Name: Midas Muffler - 101 North Avenue - Site Plan Review

Community Development Review Comments

Project: Site Plan Review for Midas Muffler and Lube Shop
Location: 101 North Avenue
File: #10-93
Petitioner: Terry McClain

SITE PLAN / LANDSCAPE PLAN

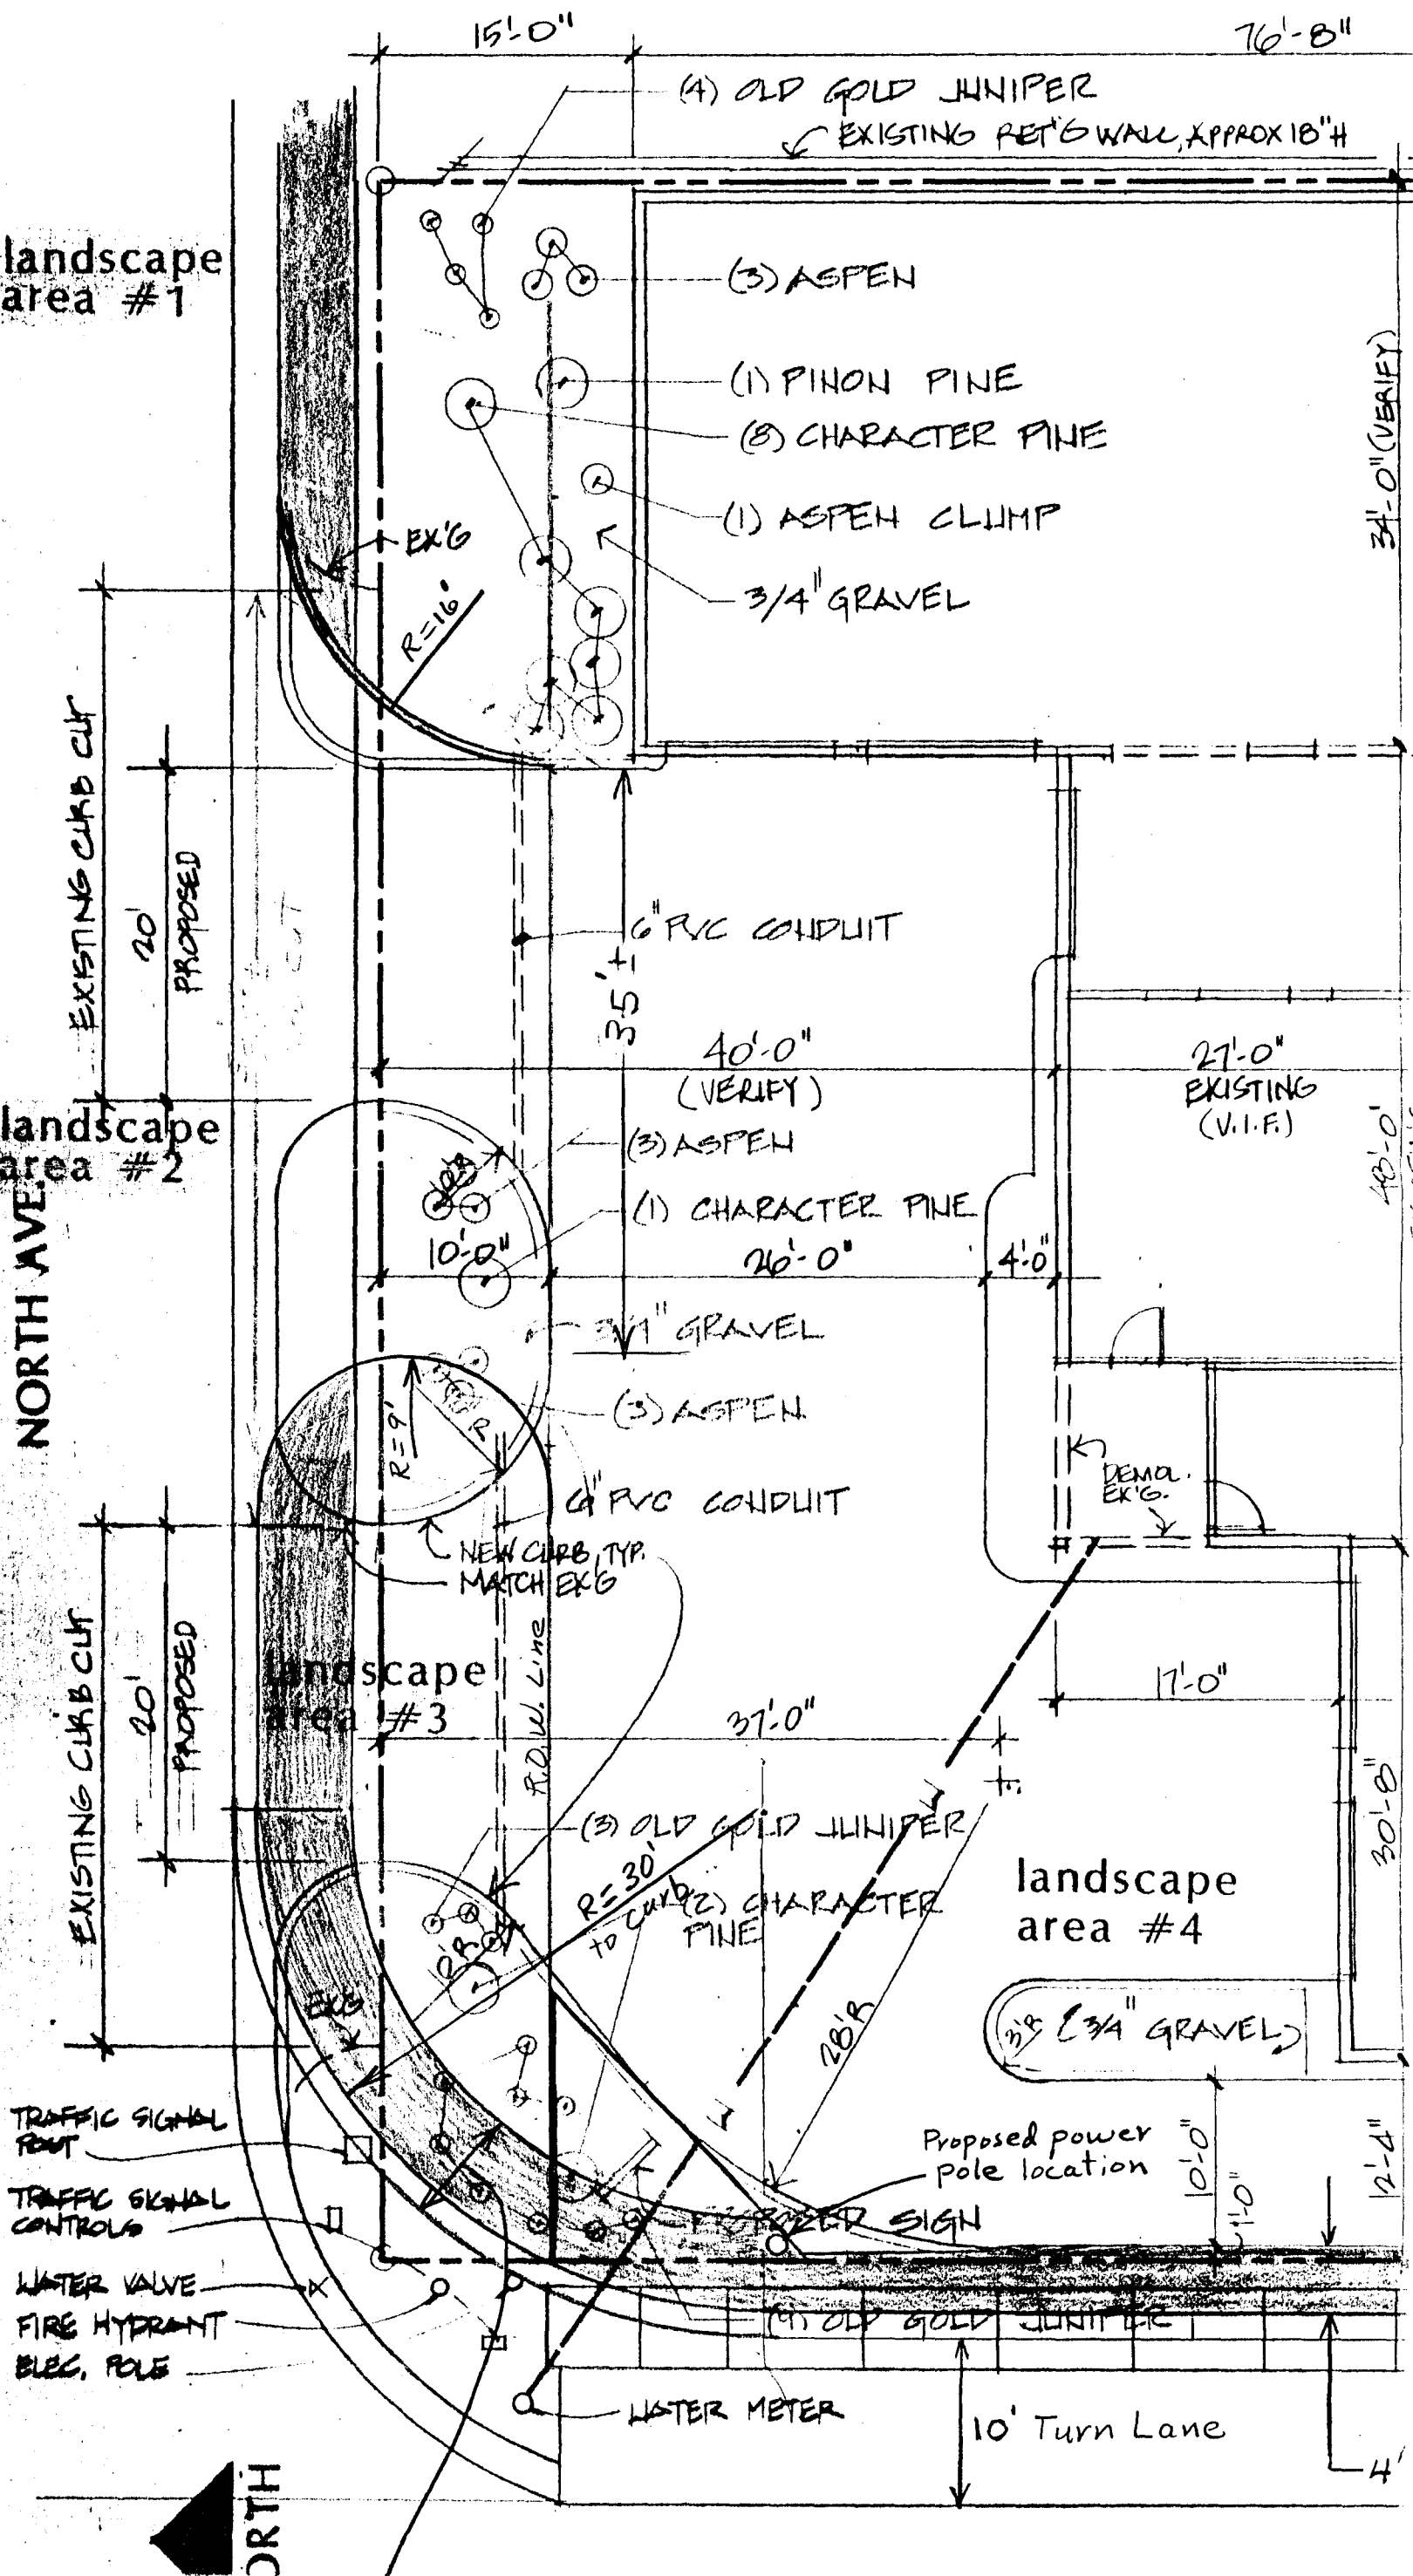
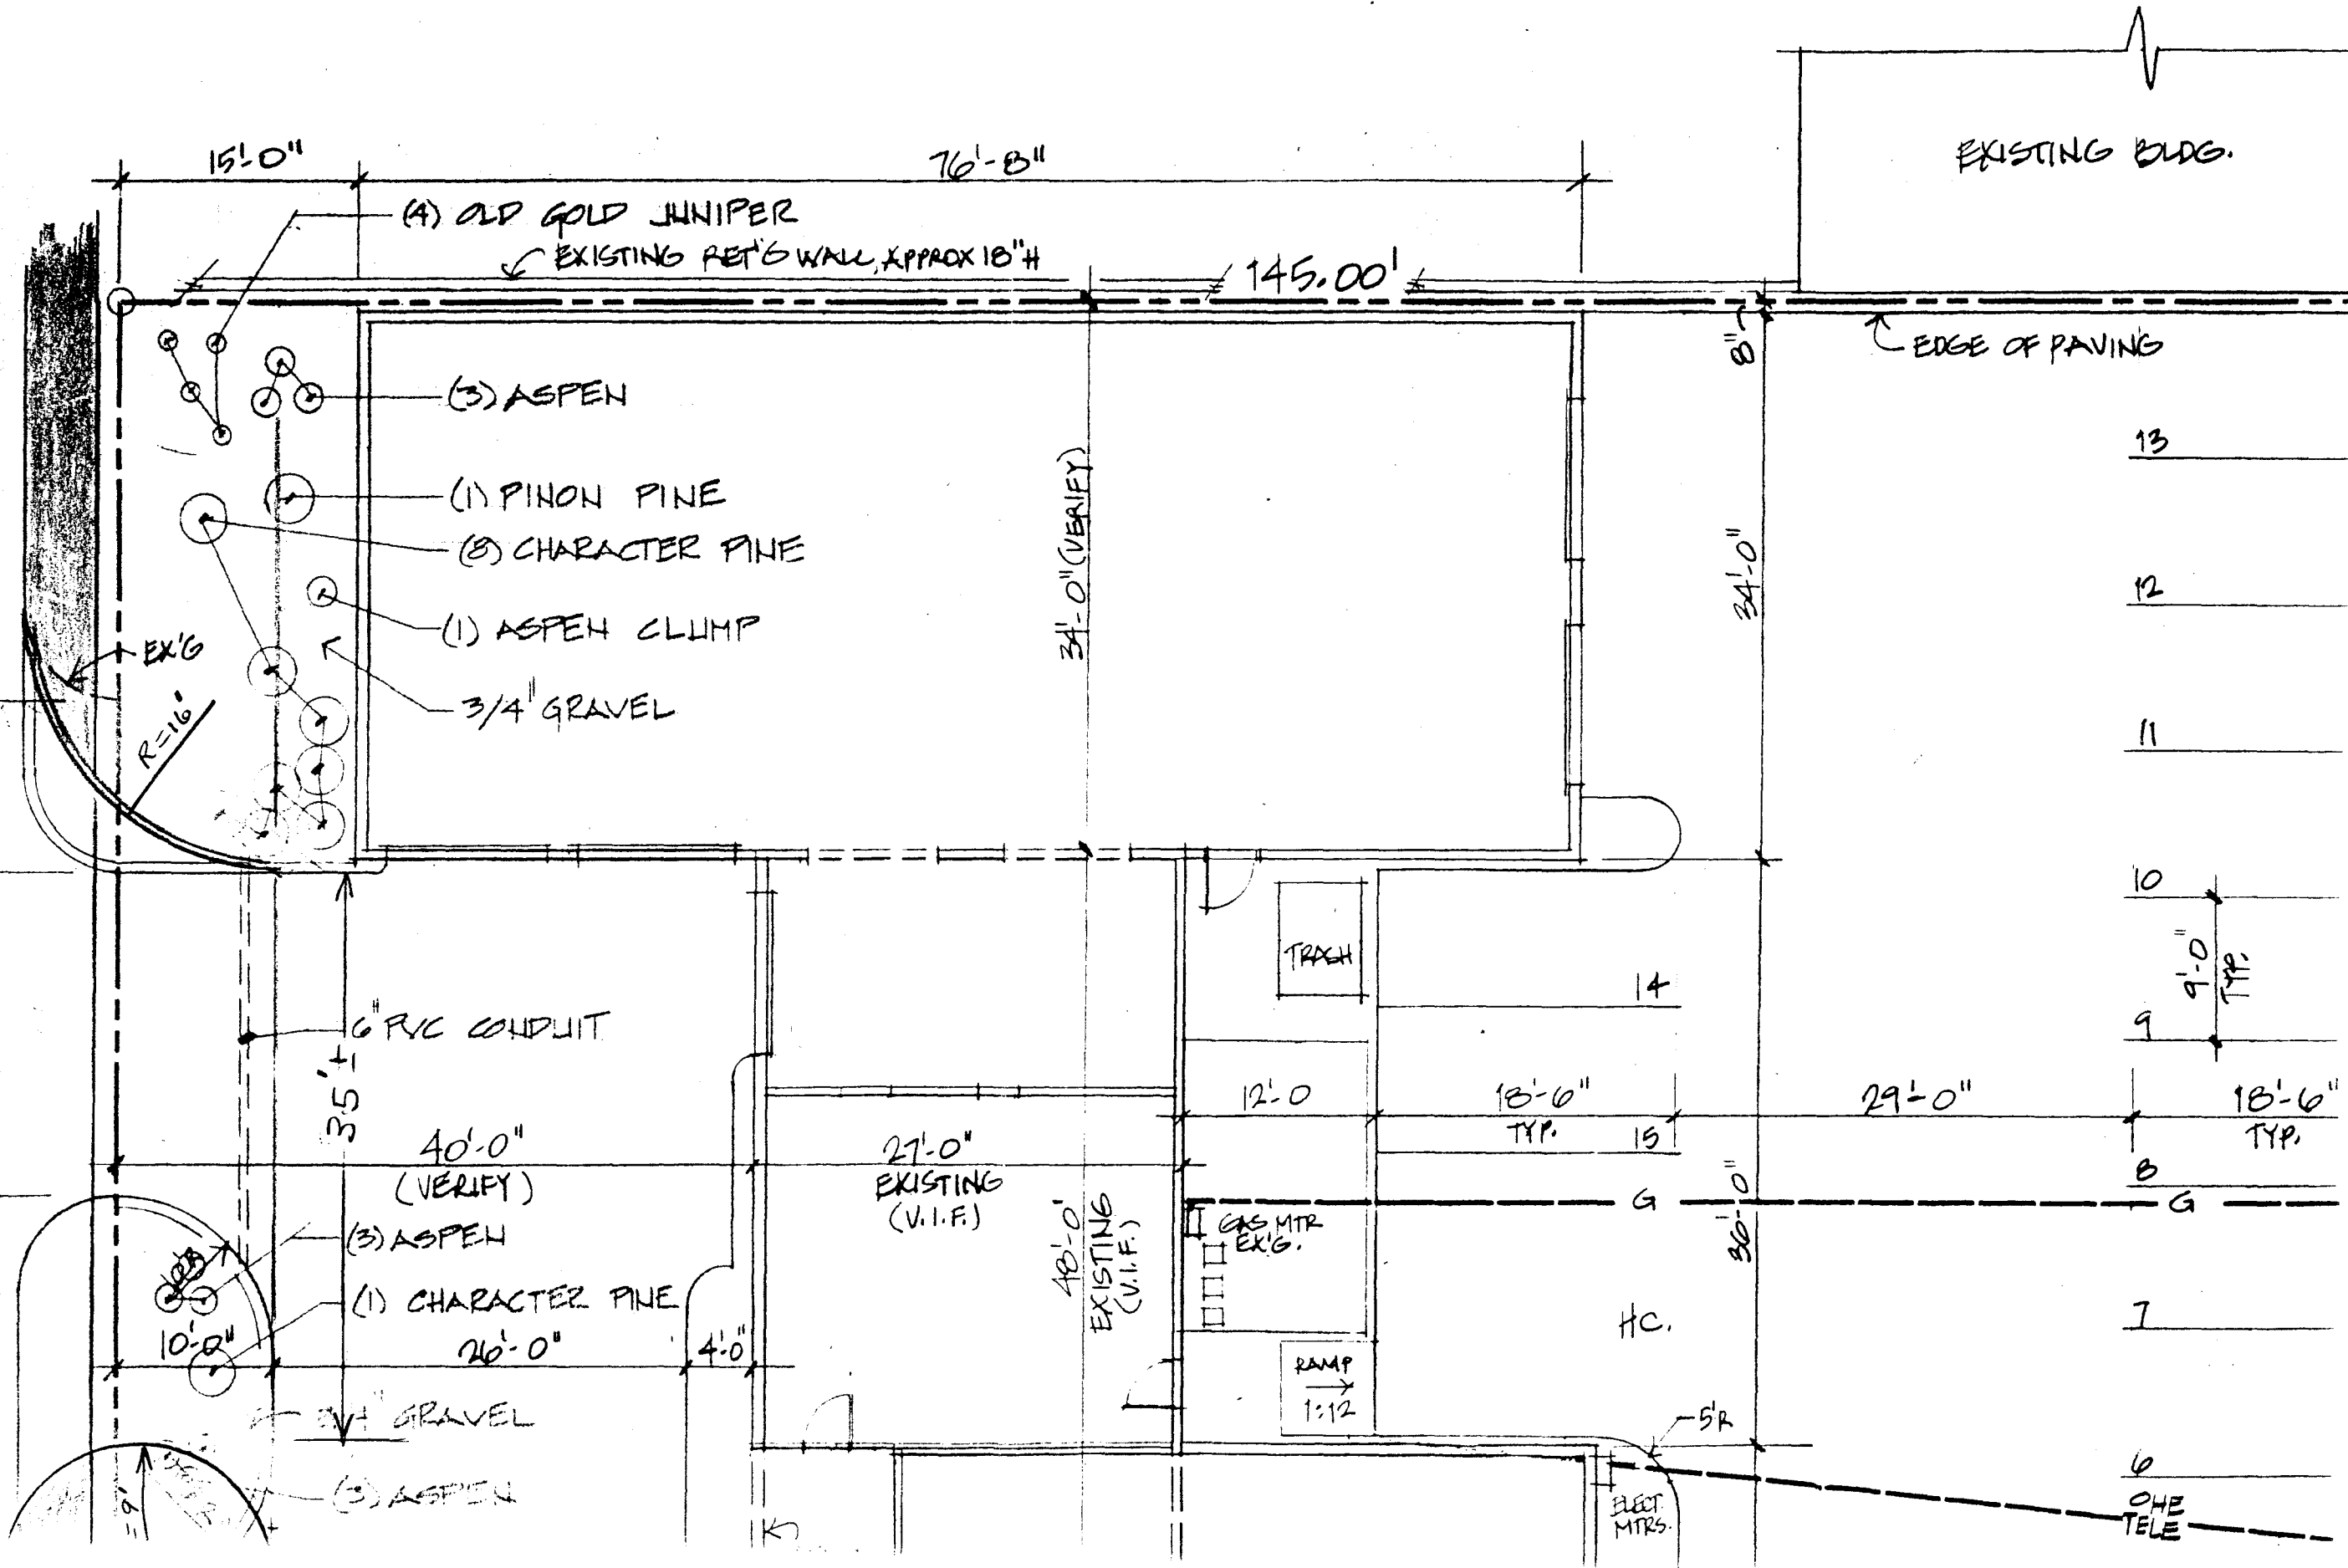
2. There is some concern about site distance for a car parked in space #1 when pulling out. You may consider replacing the "Table Top Blue" with an "Old Gold".

3. Aspen trees may not survive in the landscaped area #3 due to intense heat from the sea of asphalt around them. You may want to consider planting another specie instead like a "Marshall's Seedless Ash" or a "Sunburst Honeylocust".

- 1-3. It is my understanding that these comments are for our information only. There is no problem with the landscape design.

PREPARED FOR
O'CONNOR CONSTRUCTION
GRADING & DRAINAGE PLAN
MIDAS MUFFLER SHOP
101 NORTH AVENUE
GRAND JUNCTION, COLORADO

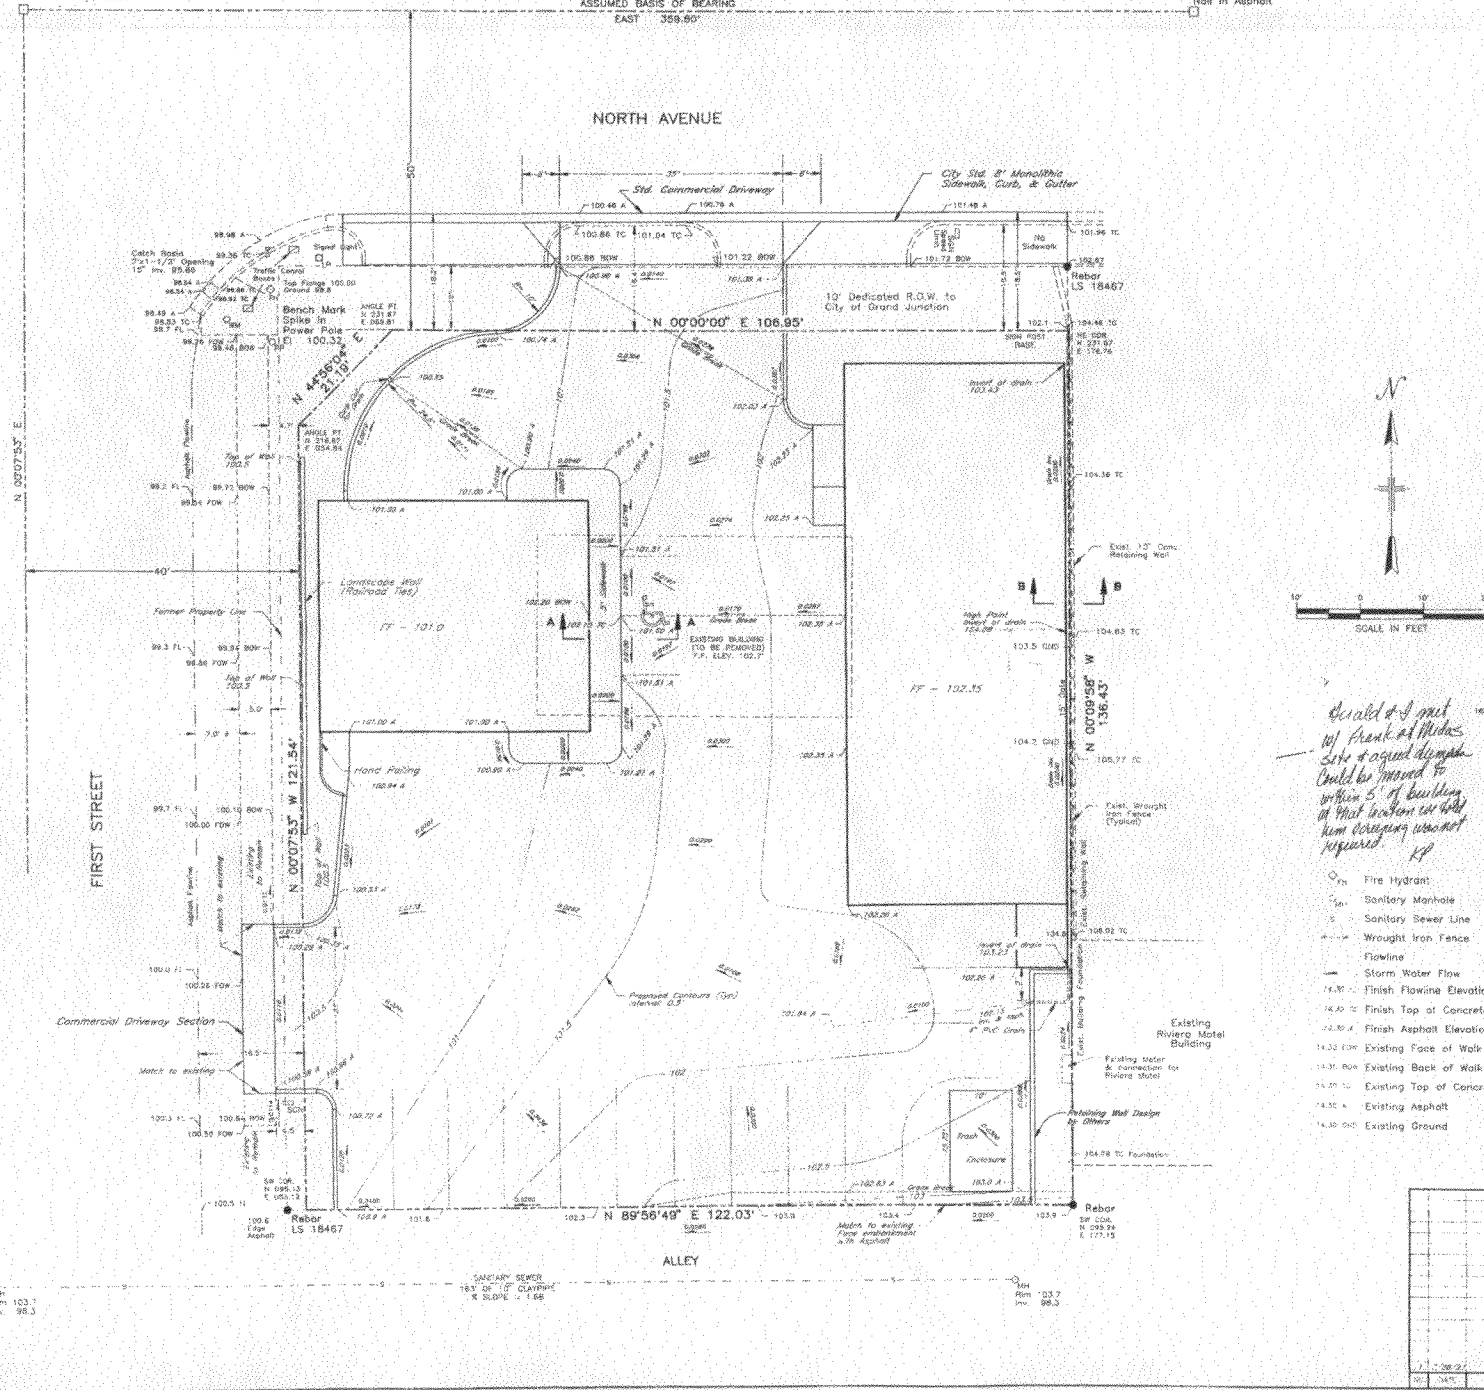
*Revised 8/8 mid
10' front of Midas
Side of original driveway
could be moved to
within 5' of building
at that location as this
has been determined was not
required LP*
